ADDENDUM NO. 2

DATE: November 7, 2013

Contract 12-C-00042; Howard F. Curren AWTP Raw Sewage Pump Station Improvements

W.O. 4506
SHEET
19

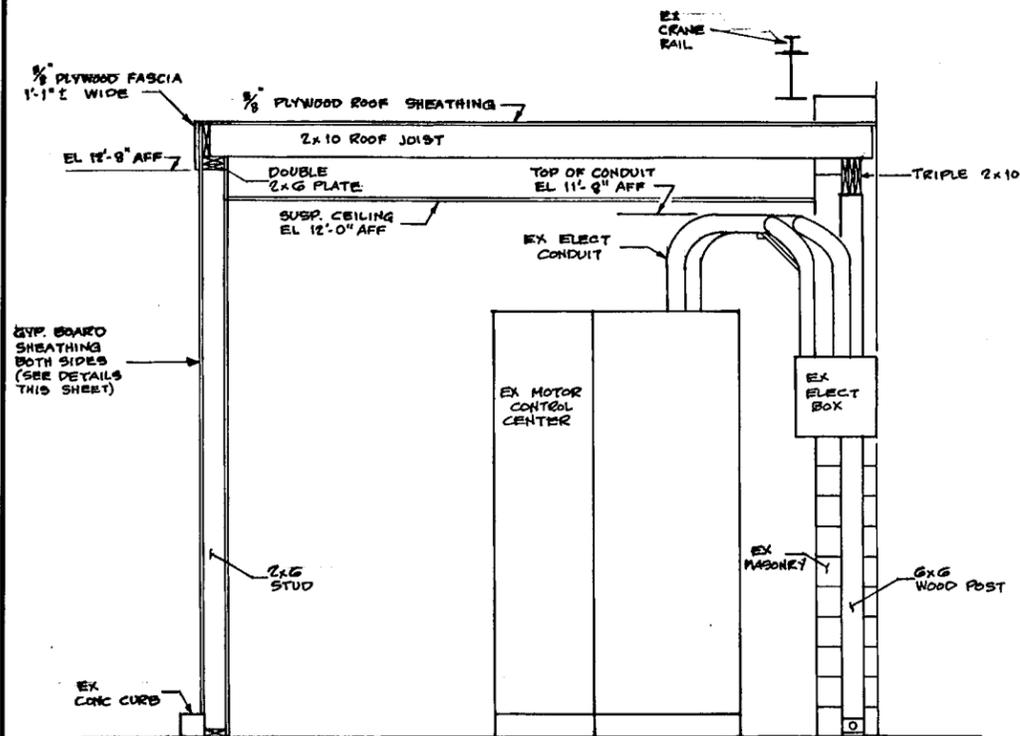
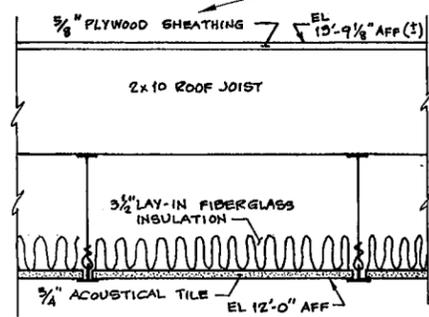
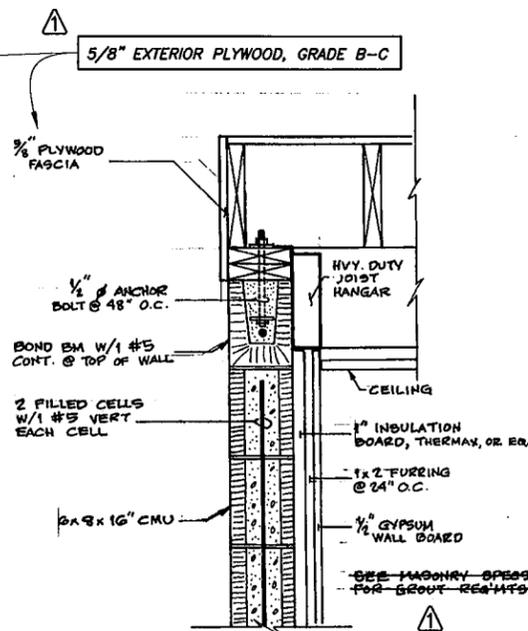
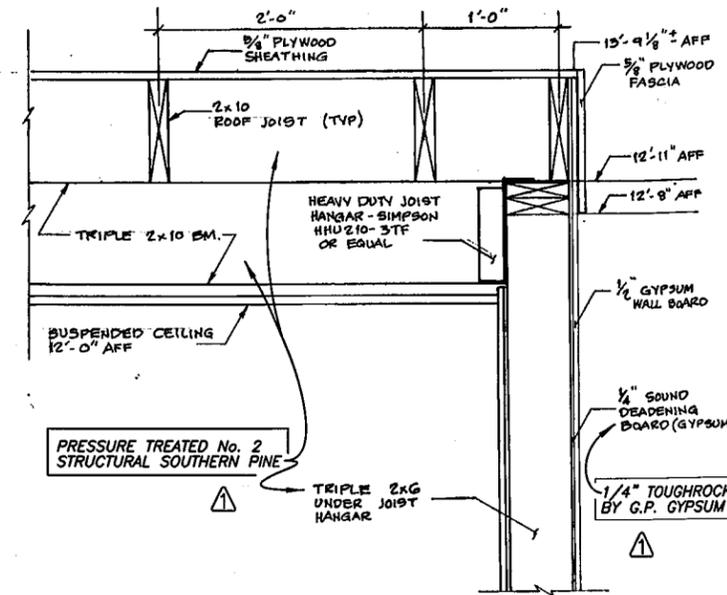
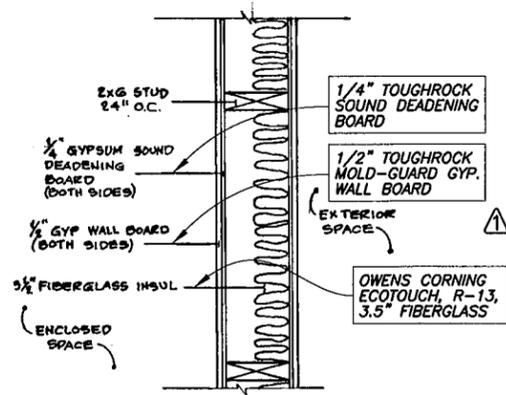
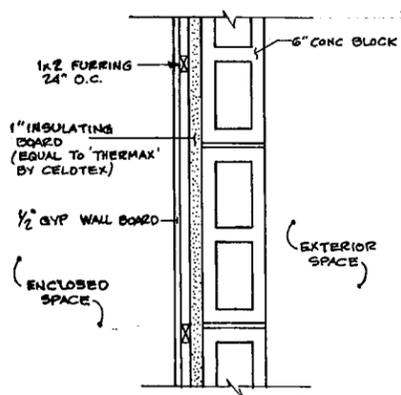
- Item 4: Existing T-Lok PVC Liner and Concrete Coating Clarification: The existing T-Lok PVC liner begins at elevation -11.60 and covers all existing concrete in the wet well above this elevation.
- Item 5: Masonry Clarification: Notes on plan sheets 18 and 19 are for informational purposes only. Masonry work is not anticipated on this project.
- Item 6: Bypass Plan Clarification: The drawing on Sheet 17 of the Plans is intended to show only the basics of the bypass pumping set-up: Where the suction manhole is and where the discharge pipe is. The Contractor is solely responsible for submitting the bypass configuration to the City for approval.
- Item 7: Manhole Dimensions: The manhole, shown on plan sheet 17, is 48-inches in diameter (I.D.) and approximately 18-feet in depth, from ground level down to channel invert.

No.	DATE	REVISIONS
3		
2		
1	11/05/13	REVISED NOTE, ADDED INFORMATIONAL NOTES AND TITLE BLOCK
